ARCHER HUMPHRYES ARCHITECTS

Presentation of duct to AV room and various options of possible re-route
Date: 30 – 09 – 2022

Image 6: Current location of MVHR 01/03 shown in Blue, this is currently now closed in by new listed decorative ceilings.

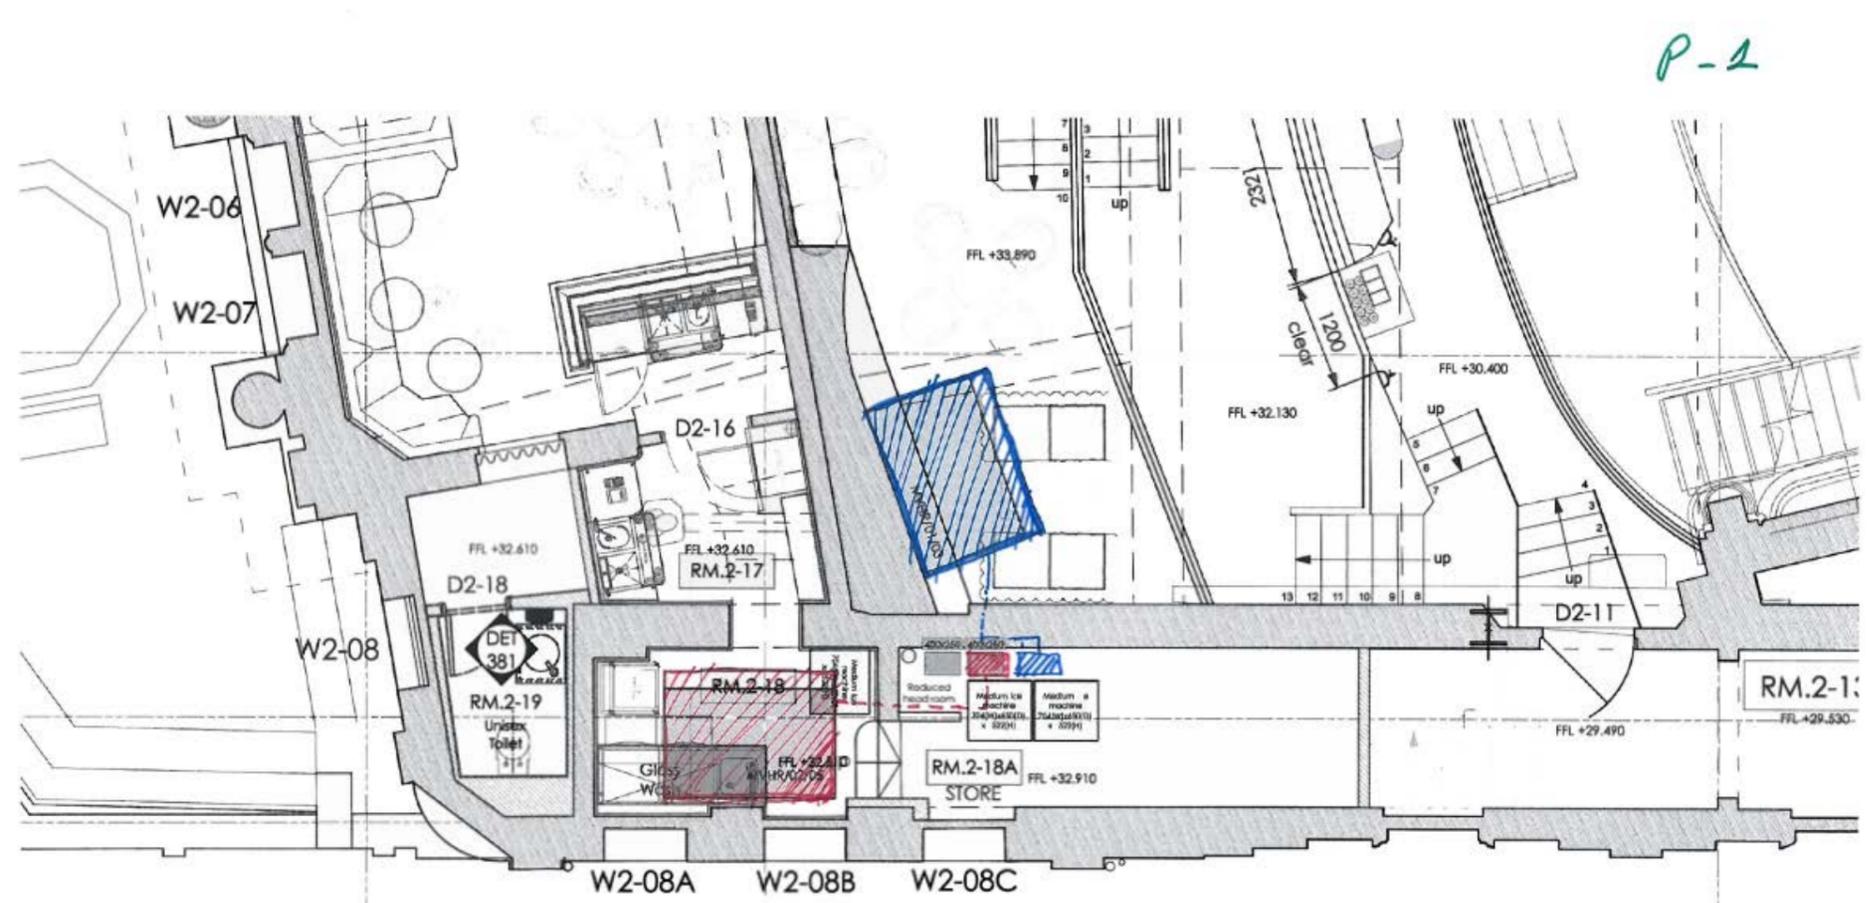
[Red hatched box] - MVHR /02 /05 - OPTION 1 TO GO UP - TO ROOF LEVEL
 - DUCT TO TRAVEL UP - OPENING ON STAIRS + ROOF

[Blue hatched box] - MVHR /01 /03 - OPTION 4 TO GO UP - TO ROOF LEVEL
 - DUCT WORK TO TRAVEL UP - OPENING ON EXISTING CORRIDOR FIRE STAIRS.

Image 5: Pink line shows electrics - RED duct location in schematic depiction.

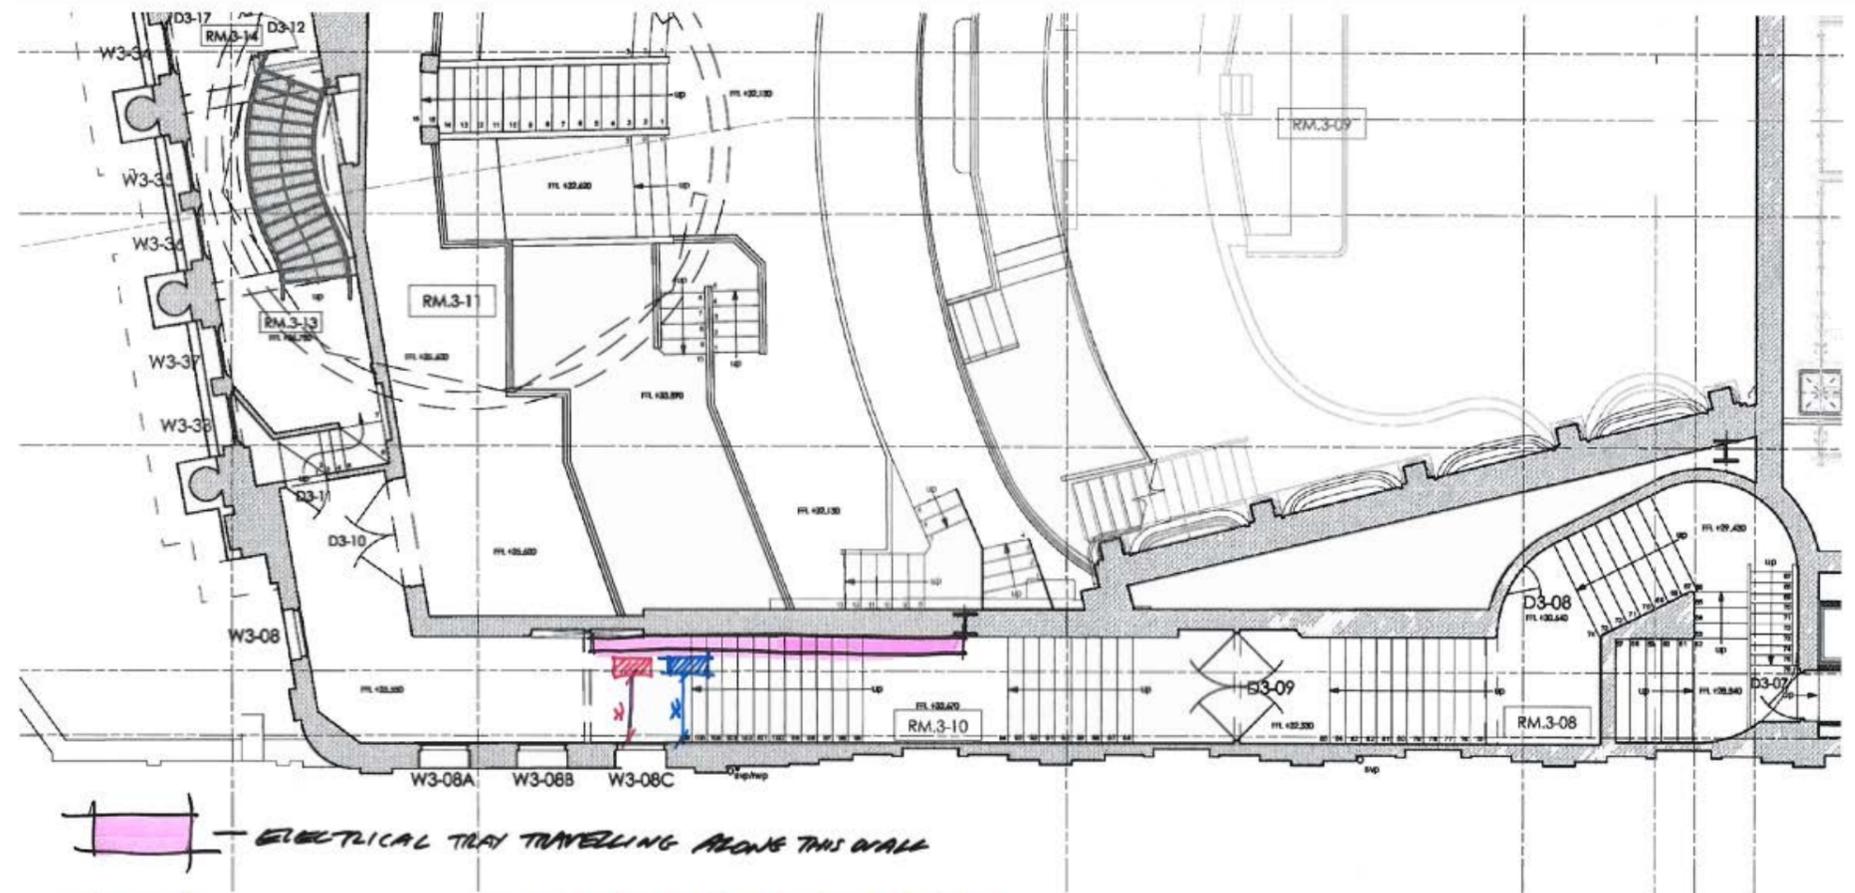
- ELECTRICAL TRAY TRAVELLING ALONG THIS WALL

- DUCT WORK TO TRAVEL FROM BELOW GOING THROUGH A CONCRETE STAIR - MAIN ESCAPE STAIRS - A.TE ESCAPE ROUTE
 1/2 DIMENSION OF STAIR WILL BE MADE NARROW IF DUCT TRAVEL THROUGH STAIRS TO ROOF - RESTRICTING ESCAPE ROUTE.

- SAME AS BLUE NOTE ABOVE.

Image 6: Current location of MVHR 01/03 shown in Blue, this is currently now closed in by new listed decorative ceilings.

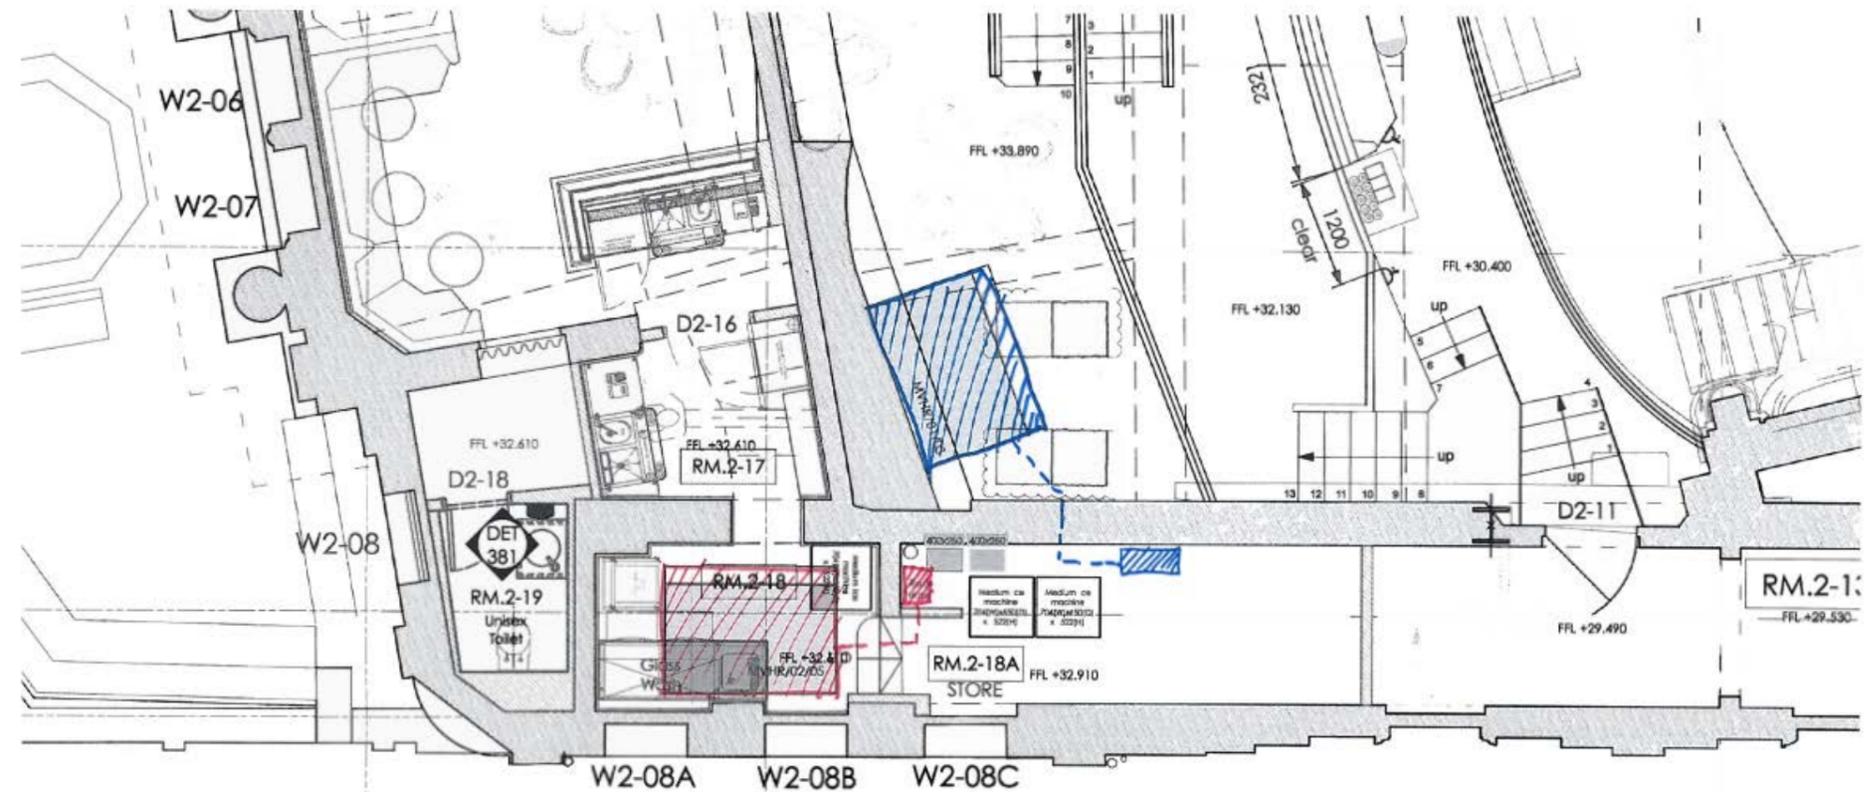
- MVHR 01/03 OPTION 2 TRAVELLING TO LOWER LEVEL WINDOW FOR EXTRACT

- MVHR 02/05 - AS ABOVE.

Image 6: Window in corridor RM – 10 below the AV room in first floor shown on sketch.
 We cannot make opening on these windows as they are listed painted glass. Therefore, we would have to go to a level below. Please see comments below on this option from consultants.

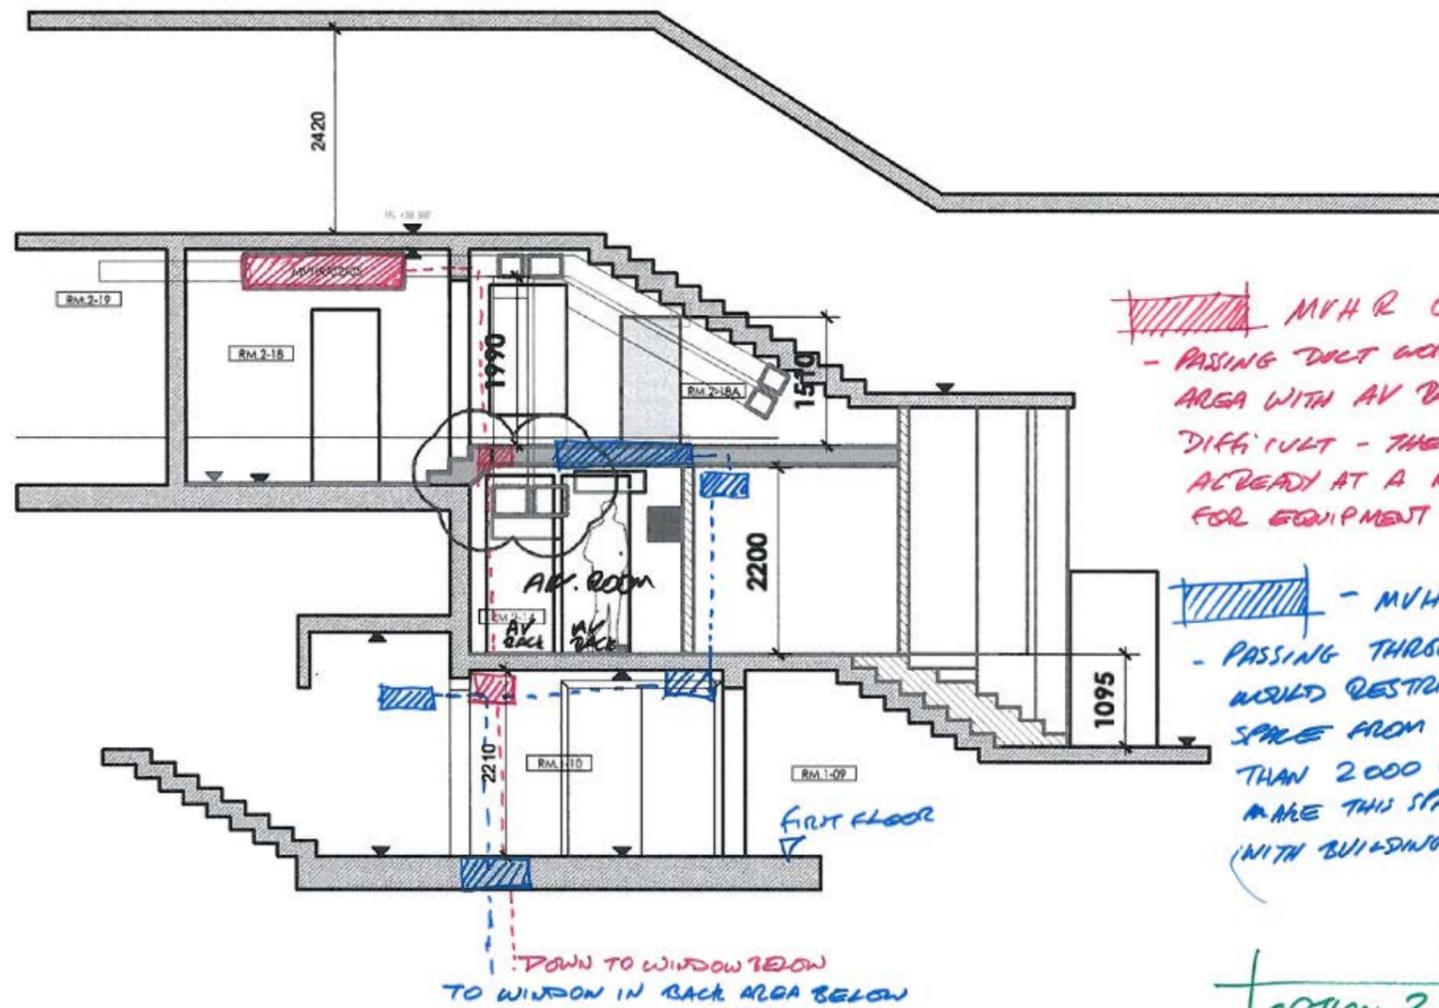
MVHR 02/05
 - PASSING DUCT WORK IN RESTRICTED AREA WITH AV RACKS SEEMS TO BE DIFFICULT - THESE AREAS ARE ALREADY AT A MAXIMUM CAPACITY FOR EQUIPMENT + MAINTENANCE.

MVHR 01/03
 - PASSING THROUGH FIRST FLOOR WOULD RESTRICT THE AVAILABLE SPACE FROM 2210 TO LESS THAN 2000 WHICH WOULD BE MAKE THIS SPACE NON COMPLIANT WITH BUILDING REGULATIONS.
